## 200M Series Mixer Body Change

In line with changes already made to other model IMPCO mixers, beginning in Q1 2021 all products in the 200M mixer line will be upgraded to include tamper-capable fuel adjustments as well as an improved diaphragm cover.

### Adjustments (Power and Idle) Change

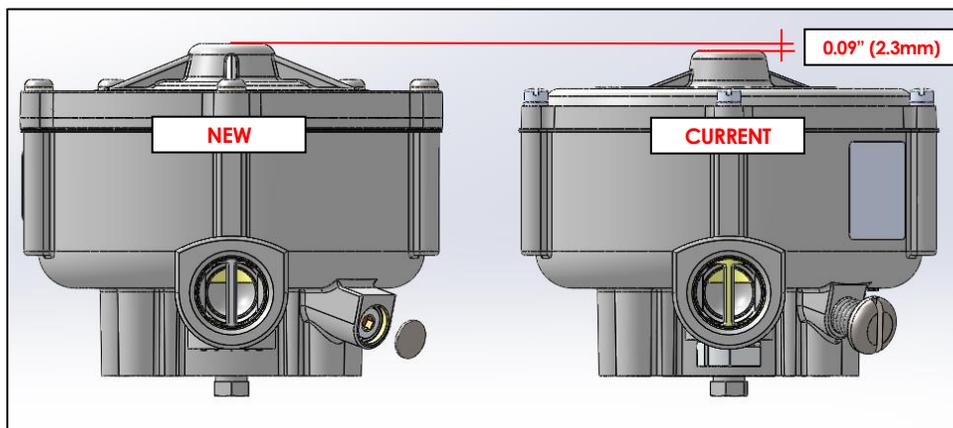
The main change is the replacement of the existing wrench adjusted power valve and slot screw adjusted idle with emissions 'tamper capable' hex drive adjustments [3/16" (5mm) idle and 1/4" (6mm) power valve] as shown;

The new diaphragm cover will increase the overall height of the part by approximately 0.090" (2.3mm).

There will be no changes to product performance / flow, and all currently available part numbers will remain available with no change in part number. Existing parts that do not already have a tamper-proof requirement will ship without caps, caps can be ordered separately if required PN: P3-17956-22 (idle) / P3-17956-20 (power valve)
